SAFETY ALERT

SA0010

SUBJECT: OIL PRESSURE LINE REPLACEMENT

MODELS AFFECTED: CC11-100 AND CC11-160 S/N 0001 THROUGH 00280

Figure 1 – Engine Fittings

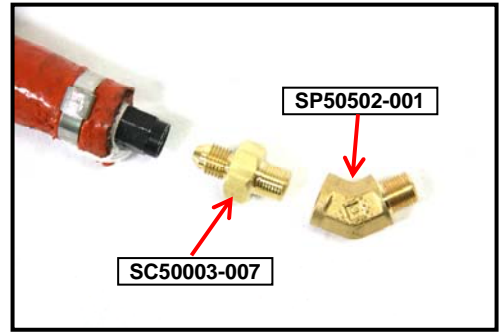
1. Read all instructions before beginning any work.
2. Remove engine cowl, retaining all fasteners (Ref. SSC10020AMM 6.3.14).
3. Remove any fasteners/cable ties securing the oil line to the engine. Disconnect the oil pressure line from the engine fitting.
4. Remove the engine fitting and replace with one of the following: (see Figure 1).

SP50502-001 fitting (45° Street Elbow) and attach a restricted fitting adapter SC50003-007 (male flare to male NPT).

Restricted fitting adapter SC50003-007 (male flare to male NPT).

Figure 2 - Firewall Sensor

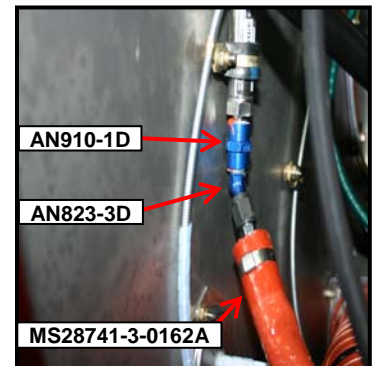
6. Disconnect the copper line and compression fitting adapter from the pressure sensor mounted to the firewall. If necessary, the entire sensor can be removed by loosening the sensor clamp. Leave any existing female to female NPT (AN910-1D) coupler attached to the sensor.
7. Install the fitting adapter AN823-3D (45° Elbow, Male NPT to Male Flare) to the AN910-1D coupler on the sensor.
8. Install the flexible hose assembly (MS28741-3-0162A) between the AN823-3D fitting adapter and the SC50003-007 fitting adapter. Secure to the dipstick tube in a similar manner as the previous copper line.

Figure 3 - CC11-160 Engine Fittings

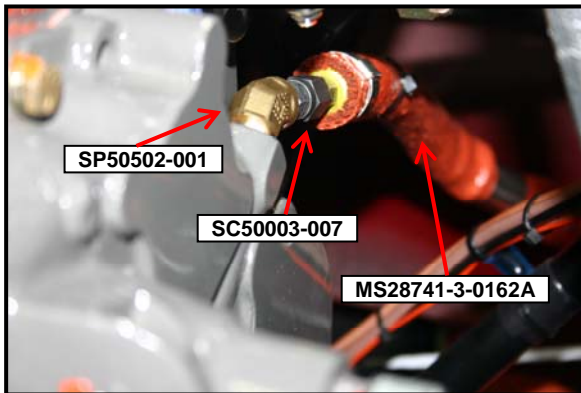
9. Remove clamp (MS21919WDG24) that secures the sensor to the firewall.
10. Replace with new cushioned clamp (MS21919WDG21) and remove the rubber cushion so the clamp's metal directly contacts the sensor.
11. Reinstall the sensor to the firewall opposite the removal if applicable, then skip to step 20.

Figure 5 - Analog Gauge Firewall Fittings

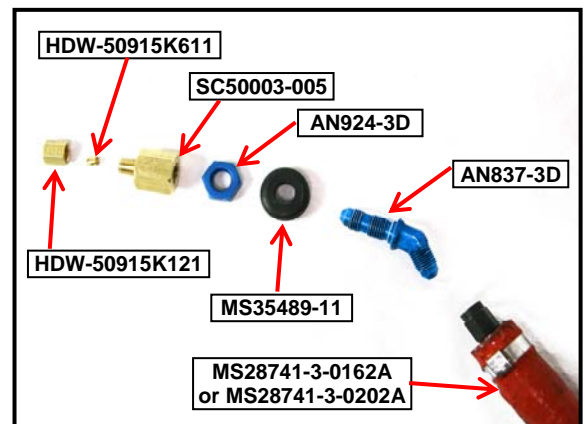
12. Using a tubing cutter, cut off the copper oil line forward of the firewall. Leave enough of the copper tubing aft of the firewall to allow it to be reinstalled to a firewall bulkhead fitting

16. Connect the fitting adapter to the bulkhead fitting and verify the connection is secure. Ensure there is clearance for the new flexible hose.
17. Tighten the bulkhead nut (AN924-3D).

Figure 6 - Firewall Compression Fittings

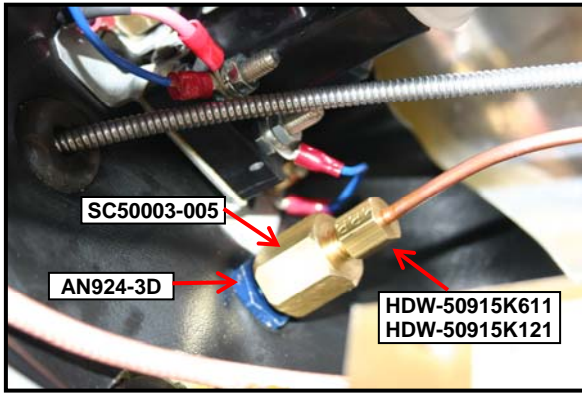
13. Slide the compression fitting sleeve (HDW-50915K611) and compression fitting nut (HDW-50915K121) over the copper tubing on the aft side of the firewall (see Figure 6).

Figure 7 - Analog Gauge Firewall Hardware

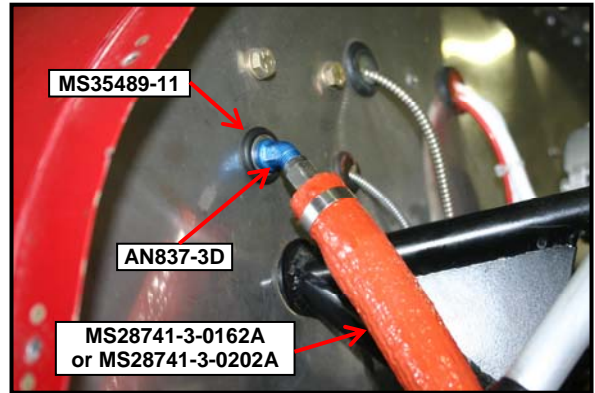
14. Install the fitting adapter SC50003-005 (Compression to female flare) marked with "37" to the copper tubing using the compression nut and sleeve.
15. Remove the synthetic rubber grommet from the firewall and replace it with a larger internal diameter grommet (MS35489-11). Install the 45° bulkhead fitting (AN837-3D) in the grommet with the 45 bend forward of the firewall (see Figure 7). Attach the bulkhead nut (AN924-3D) aft of the firewall but do not tighten yet.
